# Access Compliance Report

## Public Rights-of-Way

### (Curb Ramps)

Intersection ID: 27163	Main Street: HEATHERTON_PL	Cross Street: PROVIDENCE_ARBOURS_DR	Location: NW
ADA ID: 60CF28D92BC8	Ramp Type: Perp	Initial Pass/Fail: Fail	Overall Compliance: No
		Severity Score: 25

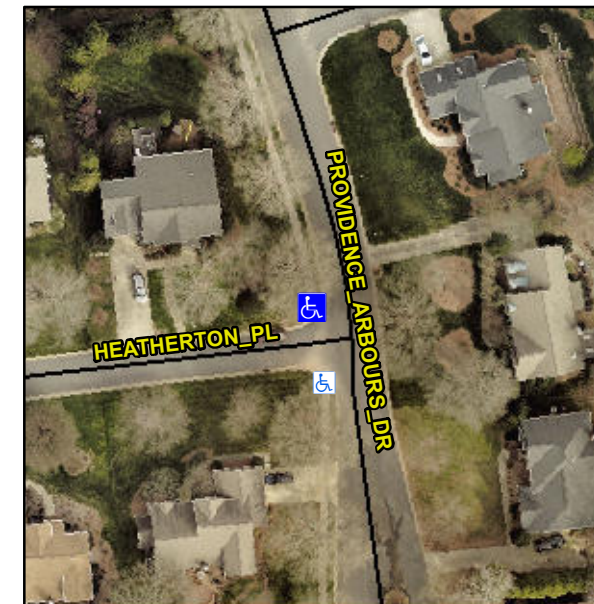
**Not Found, R304.5.3**

Compliance	Description	Data	Compliance	Description	Data
N/A	Ramp Length (in)	46.5	Yes	Ramp Slope (%)	7.0
Yes	Ramp Width (in)	74.0	No	Ramp XSlope (%)	7.1
N/A	Flare Type LT	N/A	N/A	Flare Type RT	N/A
N/A	Flare Slope LT (%)	N/A	N/A	Flare Slope RT (%)	N/A
N/A	Flare Traversable LT?	N/A	N/A	Flare Traversable RT?	N/A
N/A	Landing Length (in)	N/A	N/A	DWS Provided?	N/A
N/A	Landing Width (in)	N/A	N/A	DWS Contrast?	N/A
N/A	Landing Slope (%)	N/A	N/A	DWS Length (in)	N/A
N/A	Landing X Slope (%)	N/A	N/A	DWS Full Width?	N/A
N/A	Landing Curb? (Y/N)	N/A	N/A	DWS Offset (in)	N/A
N/A	Shared Landing?	N/A			
N/A	Gutter Ponding?	N/A	N/A	Gutter Slope (%)	N/A
N/A	Gutter Lip Ht (in)	N/A	N/A	Gutter X Slope (%)	N/A
N/A	Painted X Walk1?	No	N/A	Painted X Walk2?	N/A
	X Walk 1 Direction	To S		X Walk 2 Direction	N/A
N/A	X Walk 1 Width (in)	N/A	N/A	X Walk 2 Width (in)	N/A
	X Walk 1 Slope (%)	6.2		X Walk 2 Slope (%)	N/A
	X Walk 1 X Slope (%)	0.2		X Walk 2 X Slope (%)	N/A

**Remove & Replace Entire Ramp.**
